# THE GLEN AT WIDEFIELD FILING NO. 9

## RESIDENTIAL SUBDIVISION CONSTRUCTION DRAWINGS

**GLEN AT WIDEFIELD FILING NO. 9**  
**SPRING GLEN DRIVE (Sta. 30+00 to Sta. 43+00)**  
PLAN AND PROFILE  
EL PASO COUNTY, COLORADO

**GLEN AT WIDEFIELD FILING NO. 9  
STORM SEWER PLAN (Outfall & Offsite)  
PLAN AND PROFILE  
EL PASO COUNTY, COLORADO**

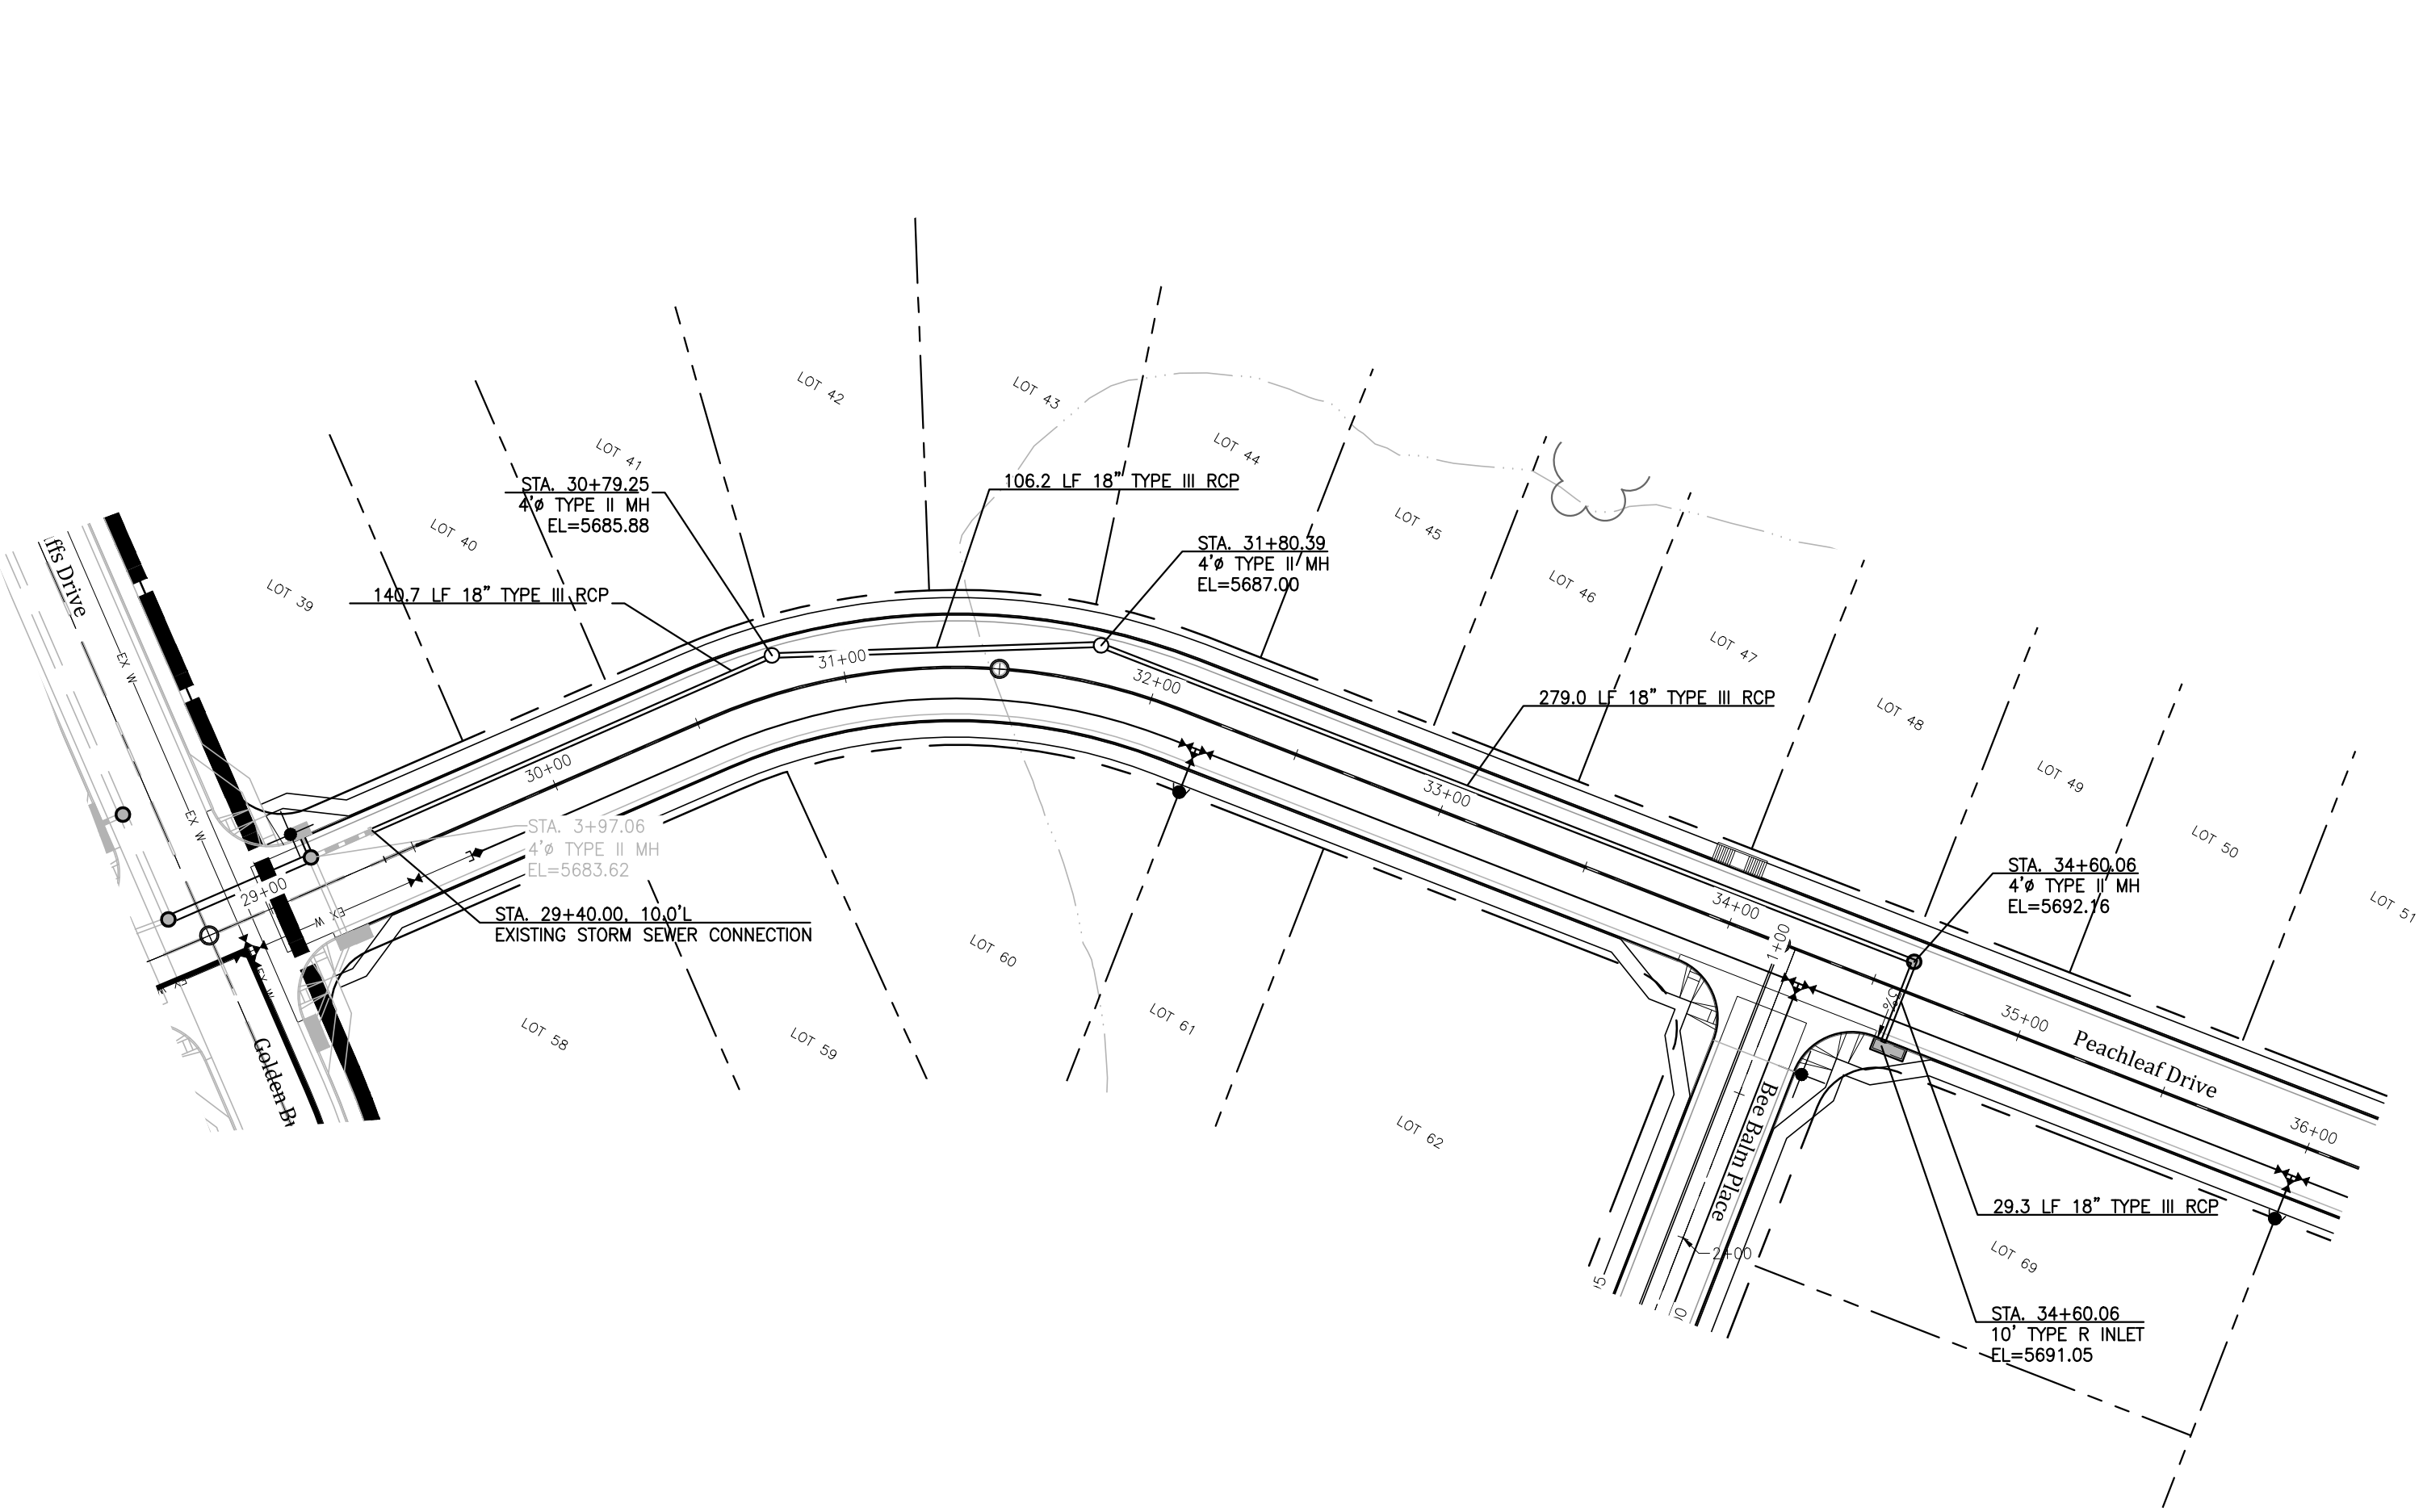
Show the ROW and provide a dimension label for the offset between the retaining wall and ROW.

Add note that no part of the retaining wall such as anchors shall be placed within the ROW.

Check with the water/sewer district if this is acceptable clearance or casing is required.
